ADDENDUM NO. 4 TO PROJECT NO. 45331

**CONSTRUCTION WORK
PROVIDE EXPANDED MIDWAY AND RV SITES
NEW YORK STATE FAIRGROUNDS
581 STATE FAIR BOULEVARD
SYRACUSE, NY**

January 21, 2016

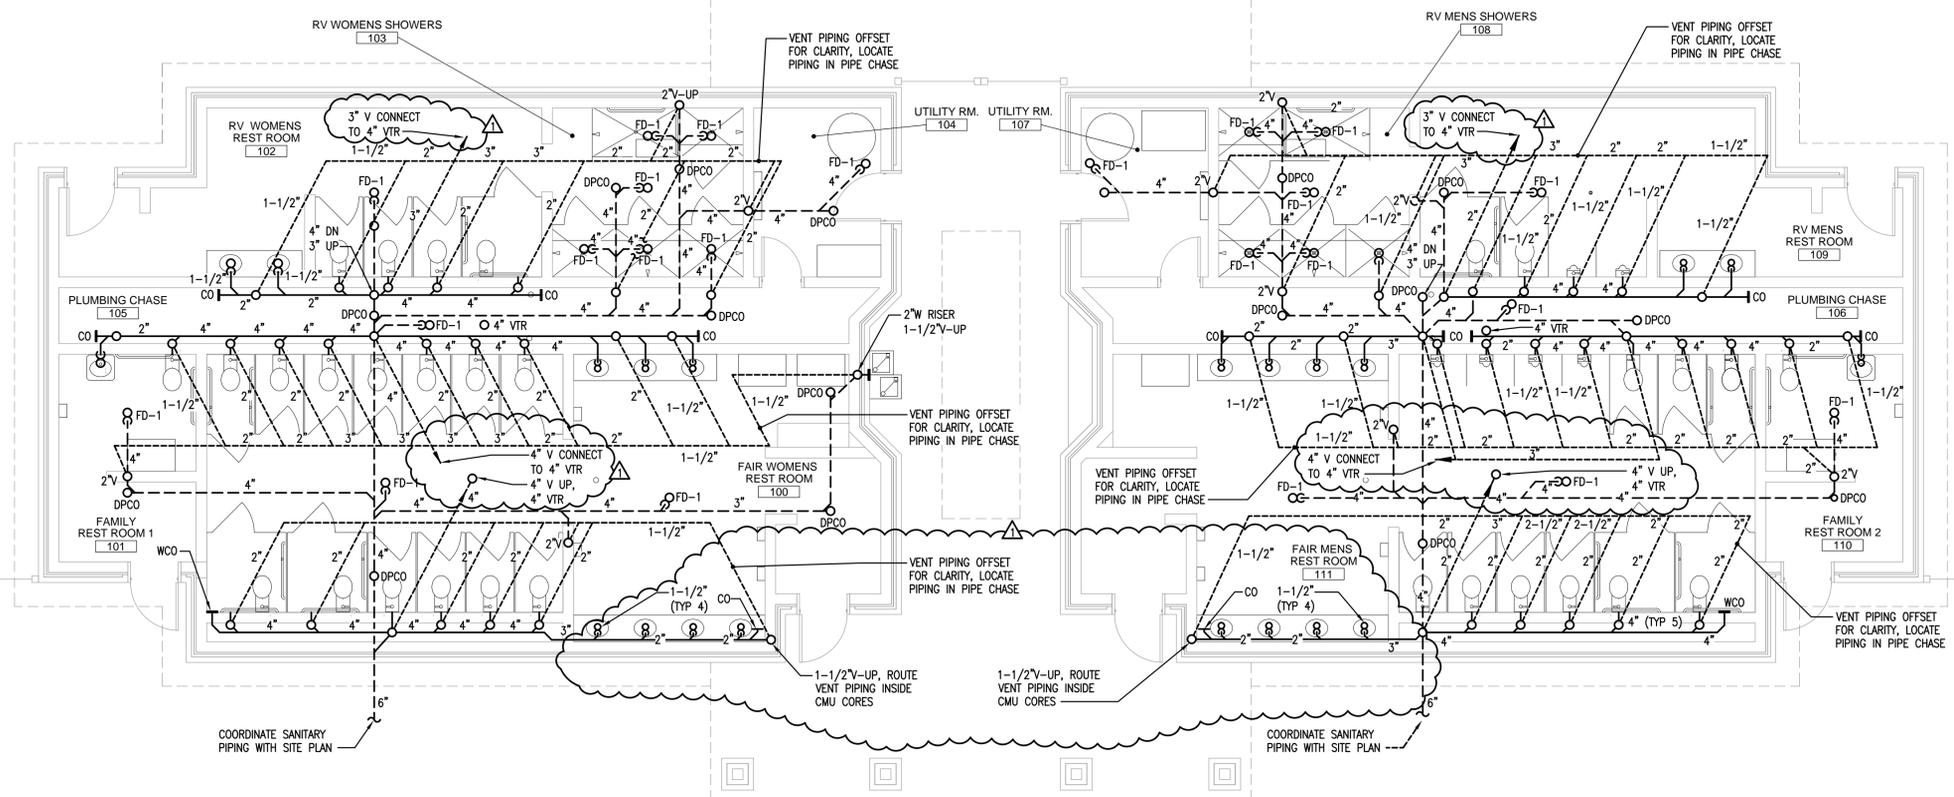
12. Drawing No. E-603, Lighting and Fixture Schedule:

- a. REPLACE items indicated in the Lighting and Fixture Schedule as indicated in the schedule provided in this Addendum.

LIGHTING UNIT	#DZL0XSD	277			
X1	LED THERMOPLASTIC EXIT SIGN. UNIVERSAL MOUNT, FIELD CONVERTIBLE TO DUAL FACE.	EMERGI-LITE #WPREMDNR	120- 277	-	-	-
X2	COMBINATION LED EXIT AND EMERGENCY LIGHTING UNIT.	EMERGI-LITE #WPR612M1R2LA	120- 277	-	-	-
LP1	CAST ALUMINUM LED ACORN, 5000 LUMEN, TYPE 3 OPTICS, ACRYLIC GLOBE, 12' ALUMINUM 4" ROUND STRAIGHT FLUTED POLE	PHILLIPS HADCO #VL71-42-A-40-3-N-N-A; OR EQUAL POLE: PHILLIPS HADCO #P2061-12-A-B-G WITH #HFP310-P4-A-N-PM ARM; OR EQUAL	120- 277		LED	-
LP2	CAST ALUMINUM LED TEARDROP, 5000 LUMEN, TYPE 3 OPTICS, ACRYLIC LONG GLOBE, 18' ALUMINUM 5" ROUND STRAIGHT FLUTED POLE WITH GOOSENECK ARM	PHILLIPS HADCO #TXF9-P-A-KL-3-N-A-5-N-S; OR EQUAL POLE: PHILLIPS HADCO #P2165-18-A-B-G; OR EQUAL WITH #HFP310-P4-A-N-PM ARM	120- 277		LED	-
LP3	FLUTED 50"H, 13" DIA. CAST ALUMINUM BOLLARD WITH 25W LED TOP CYLINDER AND CLEAR ACRYLIC LENS	SPRING CITY ELECTRICAL #ABNPRC-12-4-17-AC-LT-LE015-V8-YELO -323 -1NW-CB; OR EQUAL	208	-	LED	-

LP4	CAST ALUMINUM LED POST TOP LANTERN, 4500 LUMEN, TYPE 3 OPTICS, ACRYLIC GLOBE, 12' ALUMINUM 4" ROUND STRAIGHT FLUTED POLE	PHILLIPS LUMEC #VLR-29L700WW-G1-ACDR-C-3-UNV-CAGE-FN11-BKTX; OR EQUAL POLE: PHILLIPS HADCO #P2061-12-A-B-G WITH #HFP310-P4-A-N-PM ARM; OR EQUAL	120- 277	-	LED	-
LP5	LED HIGH MAST LIGHTING SYSTEM, 100 FT POLE. 4 - 500WATT LED FIXTURES, WINCH AND RING FOR ACCESS AND MAINTENANCE. 500 WATTS PER FIXTURE, 60,000 LUMENS PER FIXTURE.	HOLOPHANE #HMLD-12-4K-AS-G-AW-P3-PC33	208	-	LED	PROVIDE (1) PORTABLE DRIVE MOTOR FOR CABLE RING WINCH.
LP6	(NOT USED)	(NOT USED)	-	-	-	-
